Title - Sujet Mise à niveau du circuit d'eau de l	
Solicitation No. - N° de l'invitation F1700-204309/A	Amendment No. - N° modif. 009
Client Reference No. - N° de référence du client F1700-204309	Date 2020-10-23
GETS Reference No. - N° de référence de SEAG PW-\$PWY-028-8811	
File No. - N° de dossier PWY-0-43048 (038)	CCC No./N° CCC - FMS No./N° VME
Solicitation Closes - L'invitation prend fin at - à 02:00 PM on - le 2020-10-29	
Time Zone Fuseau horaire Pacific Daylight Saving Time PDT	
F.O.B. - F.A.B. Plant-Usine: <input type="checkbox"/> Destination: <input checked="" type="checkbox"/> Other-Autre: <input type="checkbox"/>	
Address Enquiries to: - Adresser toutes questions à: Chiasson (PWY), Danielle	Buyer Id - Id de l'acheteur pwy038
Telephone No. - N° de téléphone (604) 349-7097 ()	FAX No. - N° de FAX (604) 775-6633
Destination - of Goods, Services, and Construction: Destination - des biens, services et construction: DFO - Institute of Ocean Science – Sidney, BC

- 1: Extend the closing date of the solicitation
- 2: Issue Addendum No. 5
- 3: To publish drawings (for information only)

Marine Facility Water System Upgrade
Institute of Ocean Sciences, Sidney, BC
Solicitation No: F

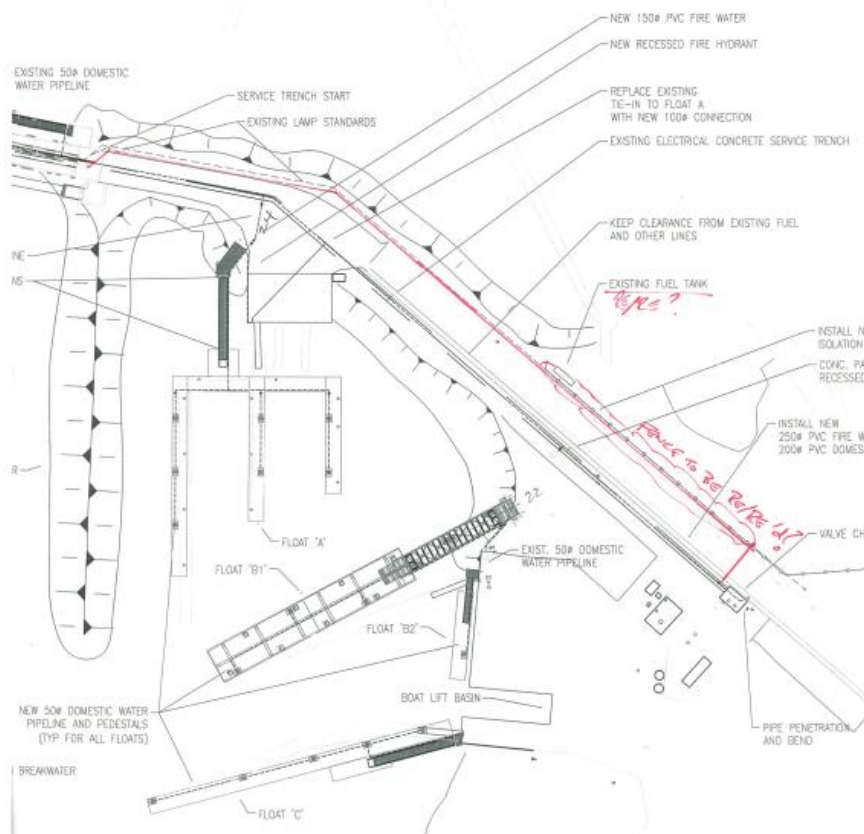
Question 1: I'm sorry to ask another question, but I feel I need some clarification on the recently posted addendum #8. Can you please see the sketch below and confirm if the red lines represent the intent of relocating the waterlines to the north side of the road? If this is the case, then the note 1 in addendum #6 with respect to no lamp standard and fence removal and replacement needs to be addressed. If the intent is to cross the road, then the fence will have to be removed and relocated. What about the fuel tank?

Answer: Refer to Drawing C006 rev4 for pipe routing. Pipe is to be routed south of the road from the existing Valve Chamber to west of the second last light standard (from fixed wharf) as shown on the Drawing. After the second last light standard, the pipes can be routed north of the road by road crossing west of the second last light standard (see sketch below).
